Ashwell Road, Bygrave

Transport Note: Summary of Post-Application Discussions

Client: Pathfinder Clean Energy Ltd

Issued by	Apex Transport Planning Ltd 11-13 Penhill Road Cardiff CF11 9PQ	Tel: 02920 619 361 info@apex.tp.co.uk www.apex.tp.co.uk	
Client	Pathfinder Clean Energy Ltd		
Project Name	Ashwell Road, Bygrave		
Report Title	Transport Note: Summary of Post-Application Discussions		
Report Ref.	TN02		
Project No.	C22028		
Date	13/06/2023

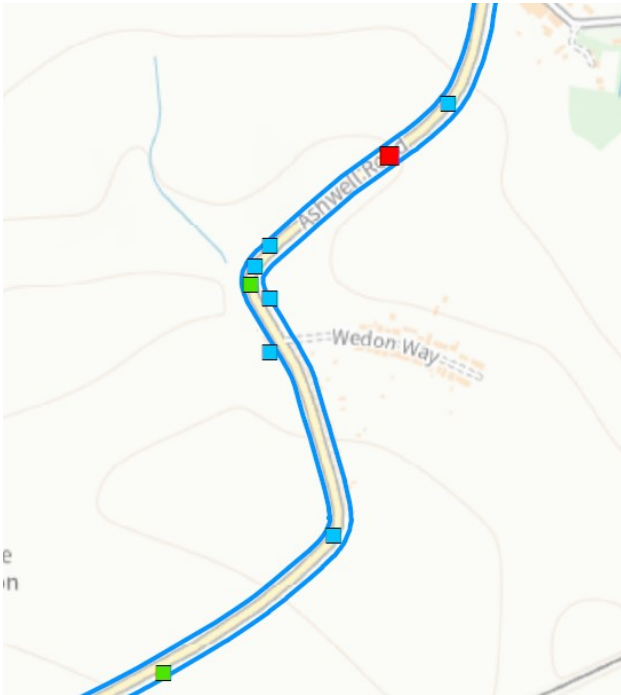
- The overriding point is that Ashwell Road / Bygrave Road is not designed for routine articulated lorry movements. The fact that its access with North Road needs widening to accommodate them testifies to this. However, with the various mitigations and measures you propose, along with the additional points we raise below, we are willing to accept an absolute maximum of 2 articulated lorry visits per day (i.e. a total of 4 two-way movements per day). I believe this level is what was presented early on, and a "slightly higher demand of 3-4" is a newer proposal which in our view tips this over the edge to a more routine daily use – along a stretch of highway which is not designed for this, and where many of its users will not be expecting vehicles of this size to approach.

- All HGVs, including articulated lorries, must only use this route between 9:30am and 2:30pm, to avoid peak hours and school opening and closing times.

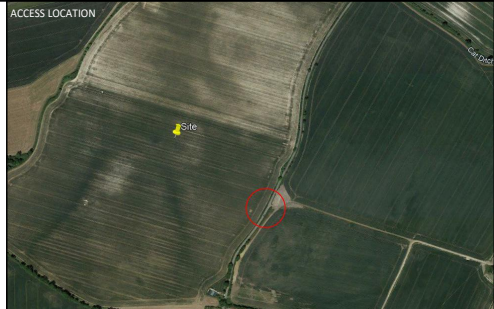
- We have thoroughly investigated accident history along the full stretch of Bygrave Road, going back to when our records started. There have been numerous accidents along the route over the years, however it's clear that most of these are driver error, involve alcohol/drugs, or in the case of pedestrians and cyclists, these have been very infrequent with no obvious pattern. What does stand out however are accidents at or on approach to bends where speed may have been issues, and there's a clear cluster around here:

Whilst accidents arising from speeding is still essentially driver error, the historic accident data implies that there is something more of a pattern and trend here, and it would seem reasonable to expect you to look into this specific section of the route in more detail, and propose measures. There are already some permanent warning signs around here, such as these:

Clearly we don't too want much in the way of sign clutter, but there might be additional signage such as 'pedestrians in road' that could help – please consider “The Traffic Signs Regulations and General Directions 2016” as a starting point, but there may be other options beyond signage too.

TITLE PROPOSED TEMPORARY CONSTRUCTION ACCESS		
ASHWELL ROAD		
PROJECT NO. C22-028	SCALE @ A3 1:1000	
STATUS DESCRIPTION INFORMATION		STATUS S2
DRAWING NO. C22028-ATP-DR-TP-009

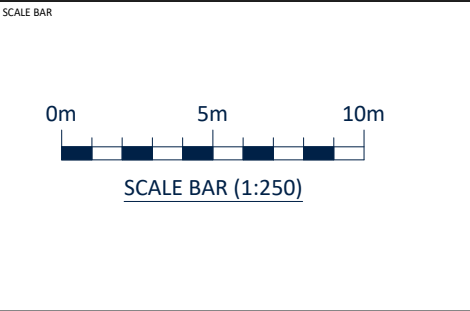
"As the Highways Authority have indicated their agreement to the final position of the construction access being dealt with via the CTMP condition, it will still be necessary to have a drawing prior to determination which clearly identifies the particular stretch of road within which this will be provided (marked by two points and a coloured line). This will provide some certainty and clarity of approximate position for all consultees and in particular, local people".

To clarify the LPAs position, we will need to re-consult interested parties including local people and interest groups/organisations on the proposed highway and other changes. As the Highways Authority have indicated their agreement to the final position of the construction access being dealt with via the CTMP condition, it will still be necessary to have a drawing prior to determination which clearly identifies the particular stretch of road within which this will be provided (marked by two points and a coloured line). This will provide some certainty and clarity of approximate position for all consultees and in particular, local people.

- 2.2.4 These discussions have also been shared with NHDC who have requested a plan indicating the potential location of the temporary construction access for planning purposes. The response is shown as follows with the indicative access location included at Appendix B. This shows that there is a length of frontage which can provide suitable visibility in each direction. The exact location of the construction access within this area will be determined by HCC at post-application stage following a speed survey which will form part of a suitably worded condition.

In relation to the comment on the proposed construction access, the applicant agrees to relocate this to the south along the site boundary with Ashwell Road, as you have suggested (Google maps location <https://goo.gl/maps/Ad5U6MErxsPoPsjQ6?coh=178571&entry=tt>). We have attached an indicative location for this access, which is based on analysis of visibility splays along the site frontage. The distances have been based on a speed survey obtained on Ashwell Road, although this was to the southwest of the site access location, it is considered likely that speeds would be similar (possibly higher) at the survey location and therefore visibility is suitable. Construction access signage will be placed at the access and on approach to the access, which will also assist in constraining vehicle speeds. Further details on the speed data and visibility is included on the attached sketch.
